SERVICE BULLETIN: JSB 029-2

Release Date: 15th July 2015

Subject: Jabiru J170 Handling Upgrade

Jabiru J170-C. S/No. Range:

Figure 1 – Fin Identification

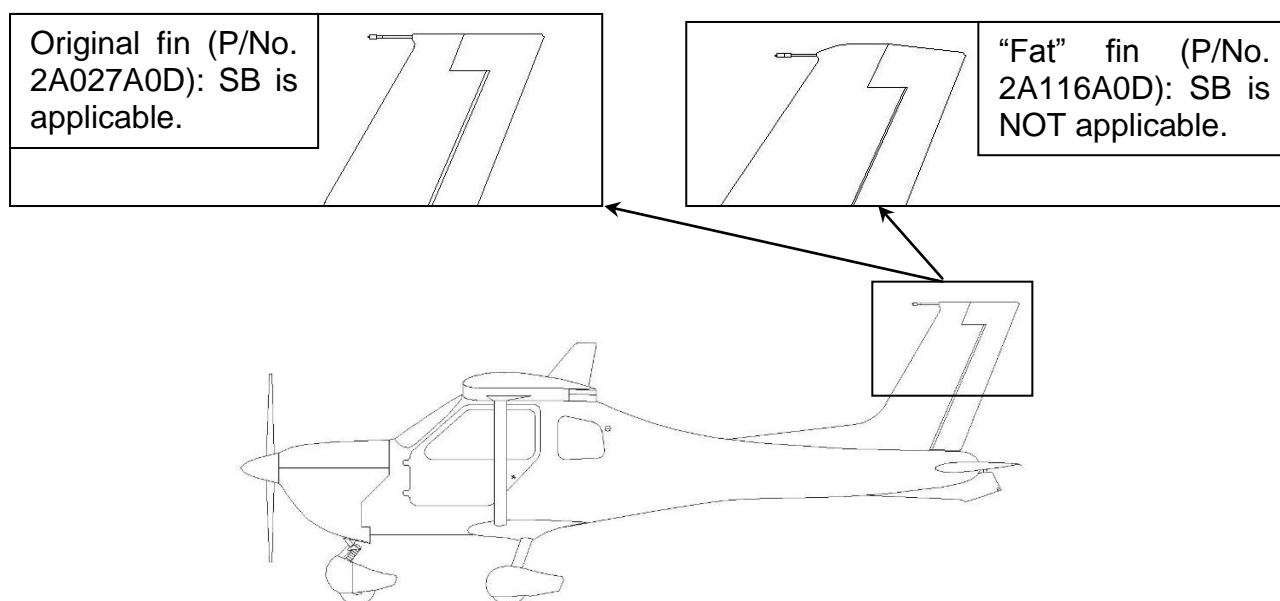
- Issue 1 was applicable to “all variants of the Jabiru J170 model”. With subsequent changes to the basic J170 configuration and the advent of the J170-D aircraft this applicability was no longer valid.
- Accordingly, Issue 2 has been prepared to clarify and limit the applicability of the bulletin.
- J170 configurations to which this bulletin is NOT applicable are most easily identified by their use of a “fat” tail fin, P/No. 2A116A0D. The most easily identified feature is the shape of the tip of the fin as shown in Figure 1.

All using fin P/No. 2A027A0D
(Figure 1, left)

Figure 3 – New Rudder Centring Springs

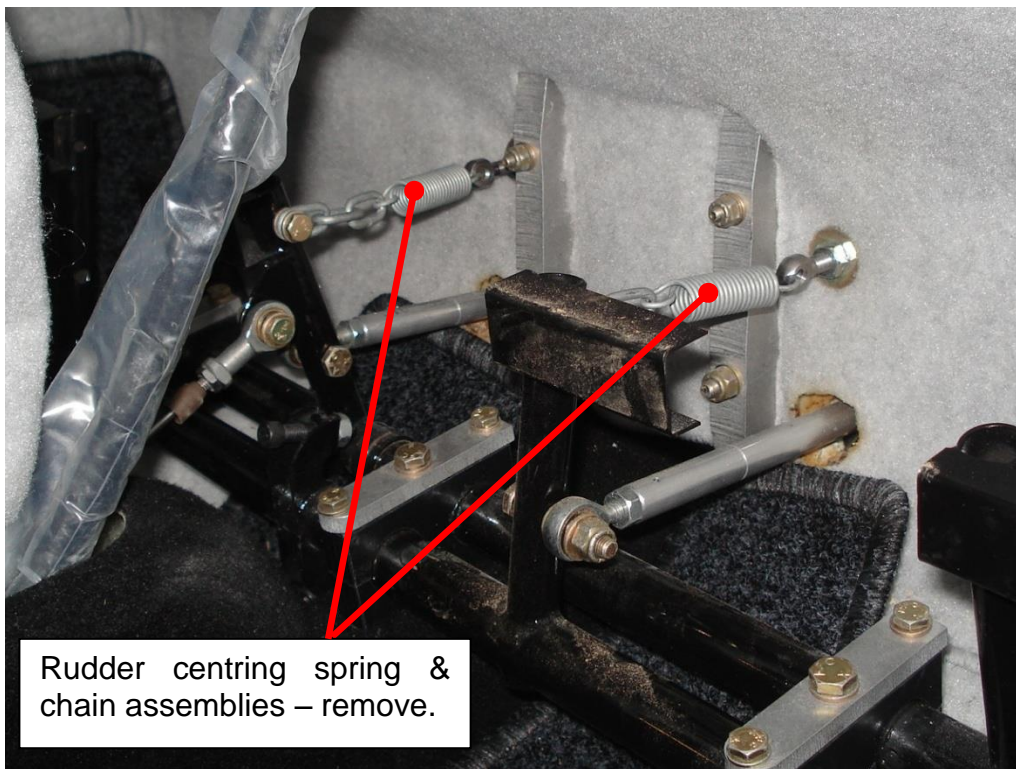
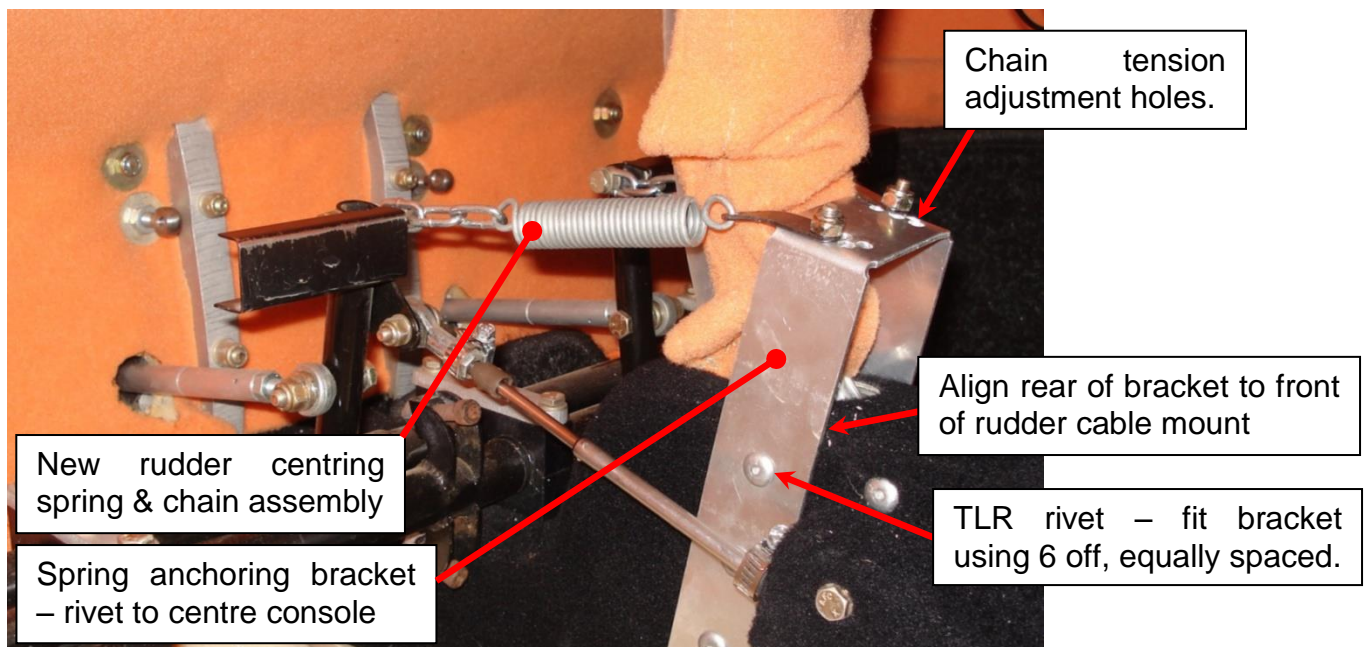
- Remove the existing rudder springs and chains from the rudder pedals.
- Fit the new spring mounting bracket to the aircraft's centre console using 6 off TLR rivets as shown in Figure 3. The exact position is not critical – but it should be aligned with the front of the rudder cable mount and positioned so that the chains and springs run as straight as possible.

- Fit the new springs as shown in Figure 3. Adjustment of these springs is important for correct handling of the aircraft. The springs must be set so that when the rudder pedals are centred neither spring is carrying any load – but as soon as the pedals move slightly a spring takes up tension. If the springs are set too tight – i.e. when the pedals are centred both springs are carrying some tension – this will reduce the centring effect of the spring system and must be avoided. If the springs are set too loose the pedals must move too far before there is any centring effect – this makes the system ineffective near centre and must also be avoided.

Figure 4 – Fitting Adaptor to Drive Arm

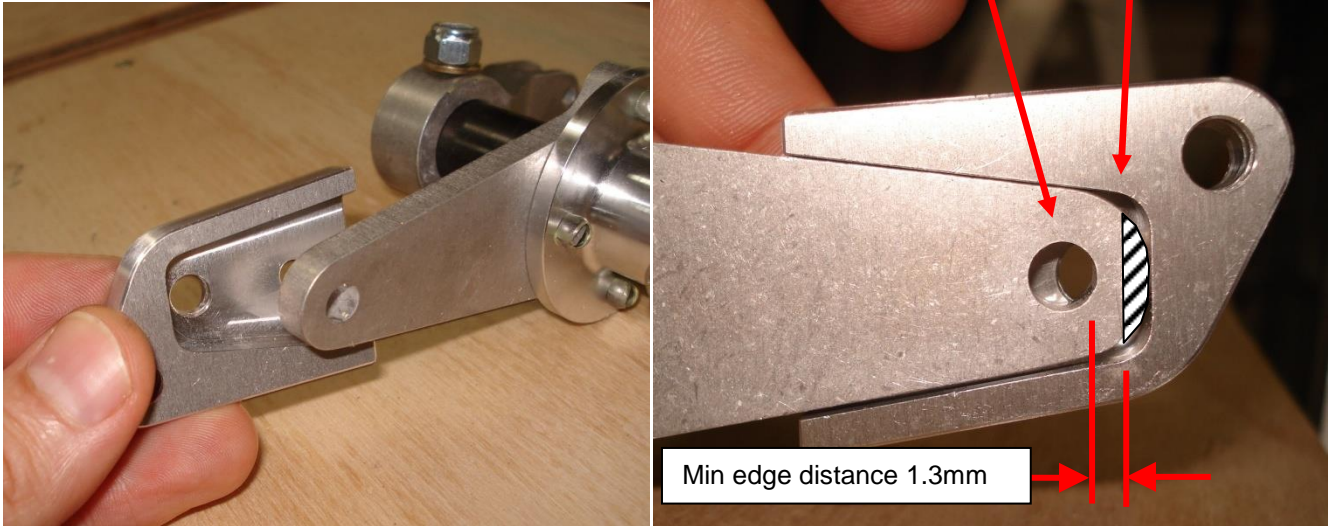
- Apply the new drive adaptor to the existing internal flap drive arm from the outboard side – it will be obvious how much material must be removed from the existing arm to fit the adaptor. Figure 4 (right) shows this. Carefully remove this material, removing just enough so that the extension slides onto the arm far enough to align the bolt holes and to fit snugly around the arm. De-burr the tip. Note the minimum edge distance shown in Figure 4 (right).

Align holes in extension
with hole in original arm.

Cut off tip of
existing arm

Use the 3/16" hole in the adaptor as a guide
to drill a matching hole in the existing arm

Figure 5 – Adaptor in Place

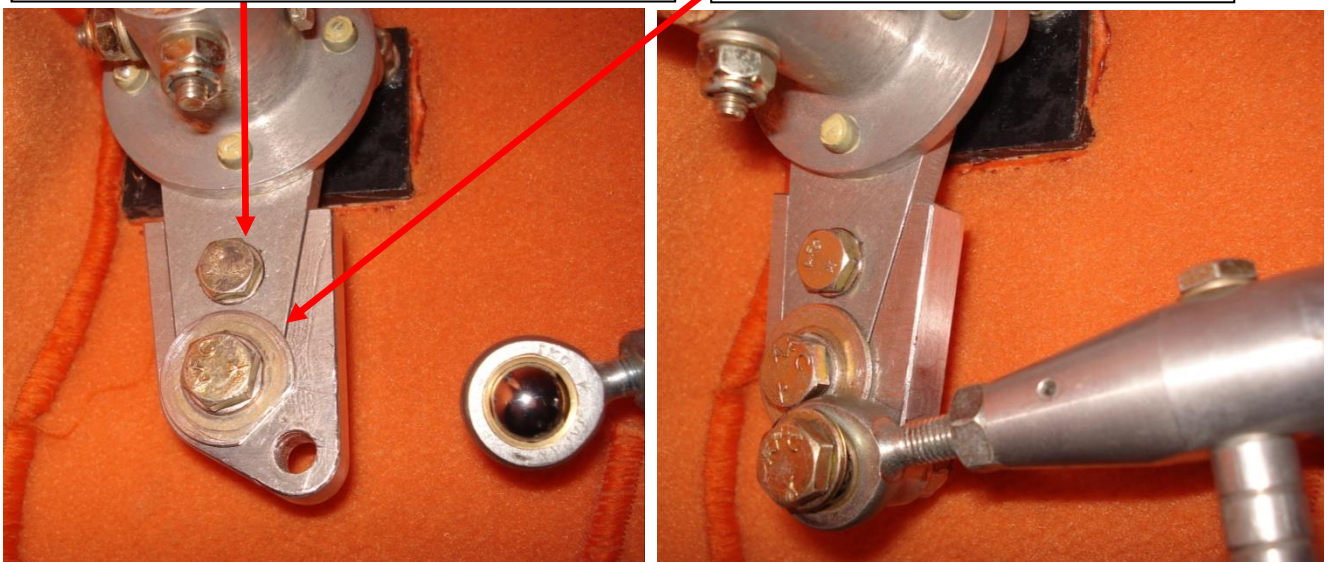
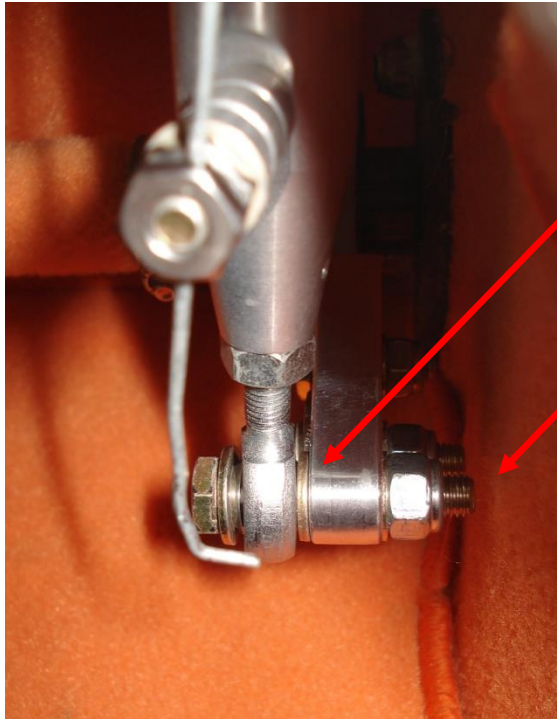
- Remove the adaptor from the drive arm. Clean it using Acetone. Mix and apply 5-minute epoxy resin to its socket.
- Bolt the adaptor to the arm using 1 off ¼” and 1 off 3/16” bolts, orienting it as shown in Figure 5. Wipe off any excess resin. Both bolts can be fitted from the cabin side of the drive arm – care will be needed to use the correct length bolt so that the tails of the bolts do not rub on the side of the fuselage. If required AN363 or MS21042 nuts may be used as they are thinner than Nylock-type nuts.

Adaptor bolted & bonded in place.
Use of penny washer is optional.

Spacer washer to prevent drive shaft binding

Note clearance between bolt and fuselage side

Figure 8 – New Ventral Fin Fitted

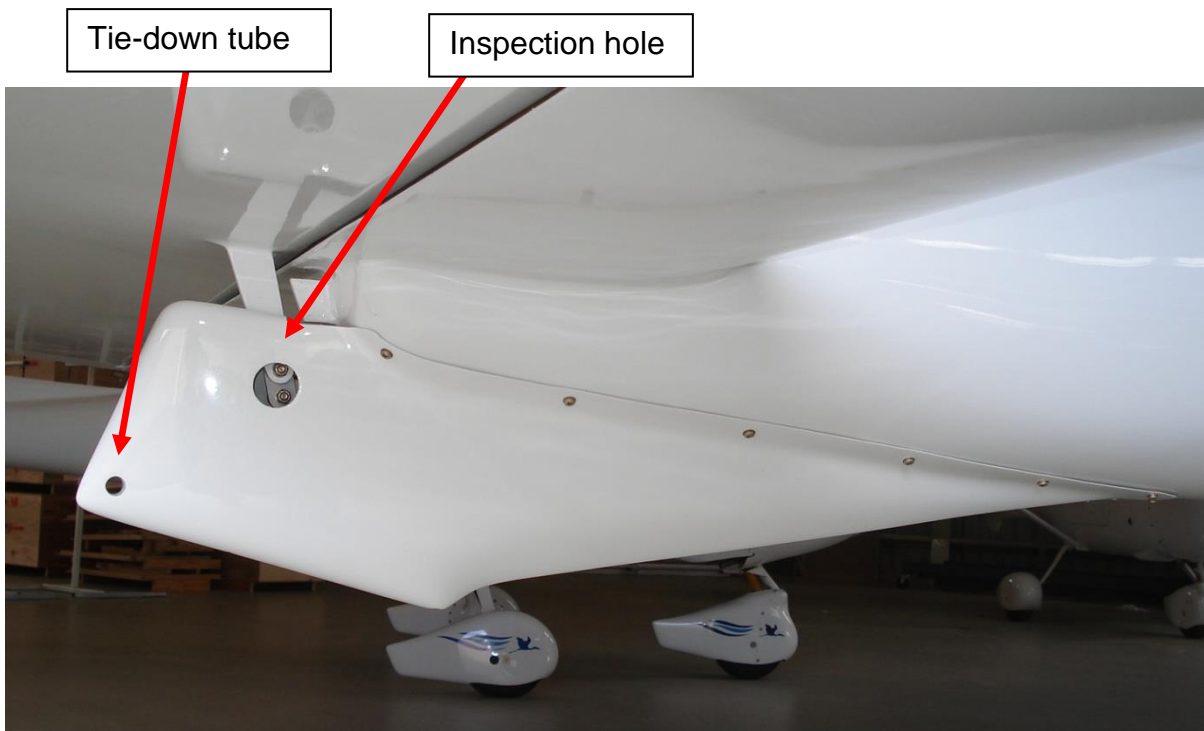
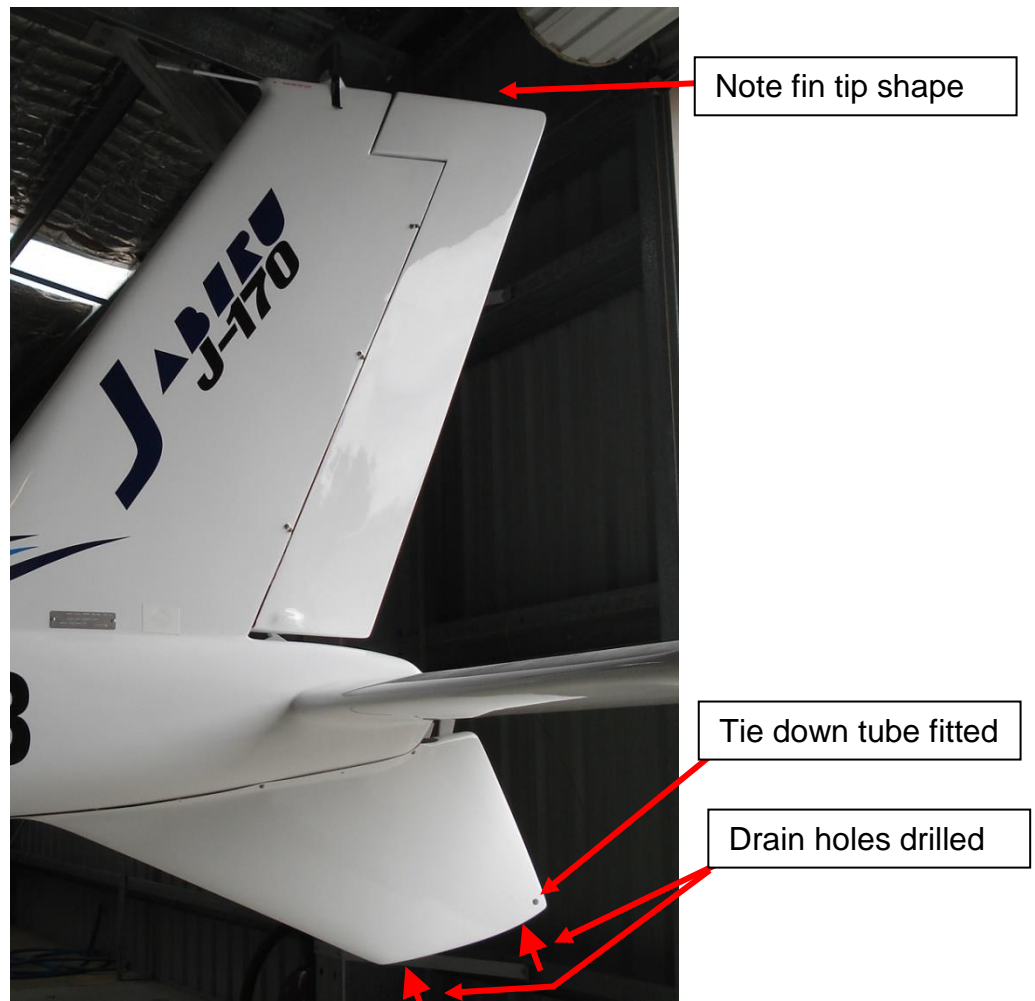
- Remove the existing ventral fin and weigh it accurately.
- Cut the inspection hole and fit the tie-down tube to the new ventral fin. Drill two ¼” drain holes in the bottom of the fin at the positions indicated in Figure 8. Paint to match the aircraft.

- Weigh the replacement fin accurately.
- Fit the new fin.
- Some J170 aircraft operate quite close to the rear of their CG envelope and in some cases the extra weight added by this new ventral fin will be sufficient for the aircraft to exceed its rear CG limit in some load cases. Operators must calculate the effect that changing this part has had on their aircraft and assess if any ballast or operating changes are required. Depending on the category in which the aircraft is operating these calculations may need to be carried out by an approved Weight Control Authority.
